ST/SG/AC.10/C.3/2008/105
22 September 2008

HSL Flash Composition Test

Transmitted by the expert from the United Kingdom¹

Figure X. X .2 Apparatus

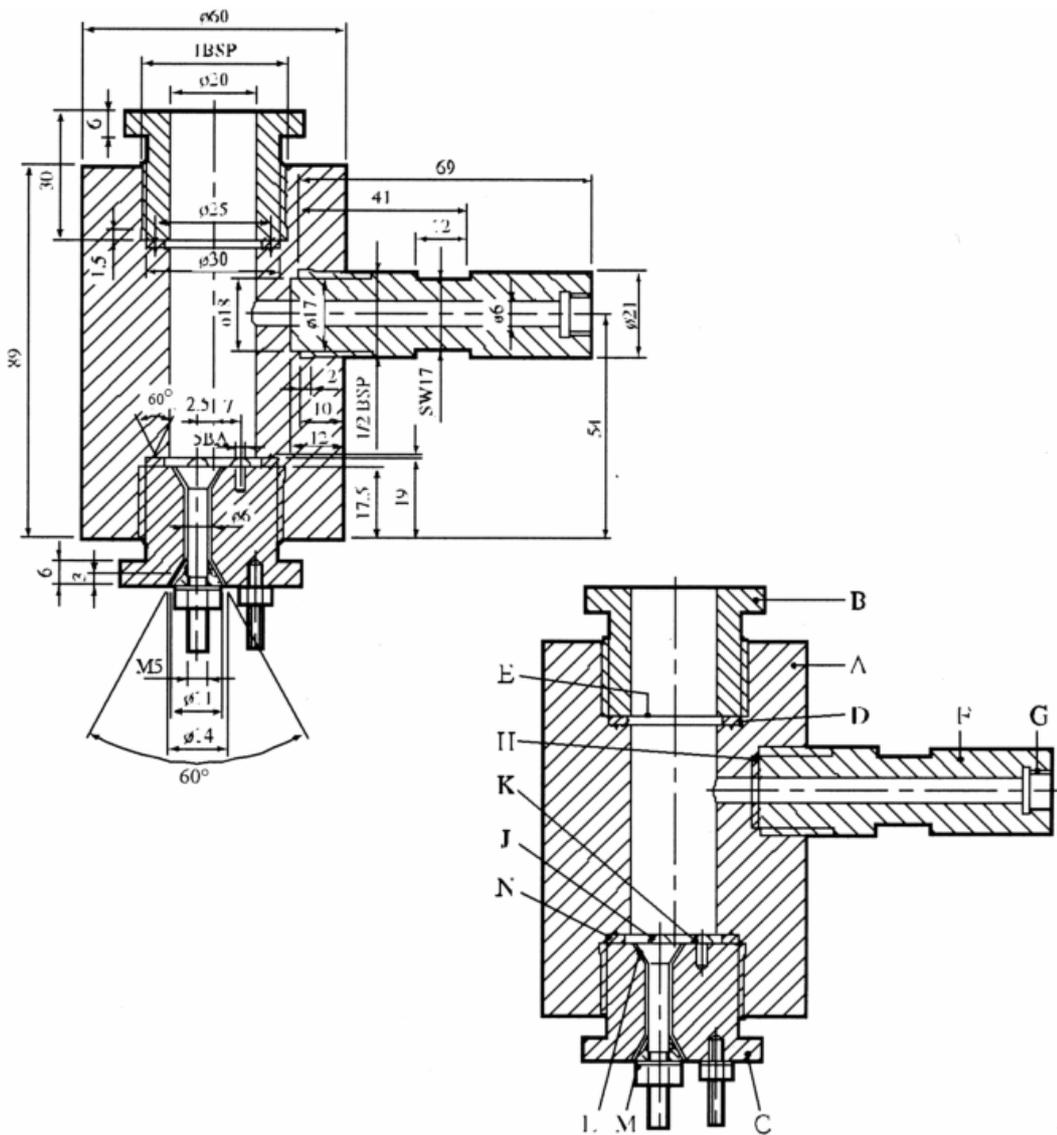
[Note: the Drawing X.X.2 is to be replaced with a new drawing showing the new Cone in Plug firing plug and Drawing X.X.8 is to be redrawn. These will be included in an informal document. Comments have been received from a number of Experts and where possible these have been included. Some of these comments and changes are in square brackets. The informal document will deal with these issues following further comments by Experts]
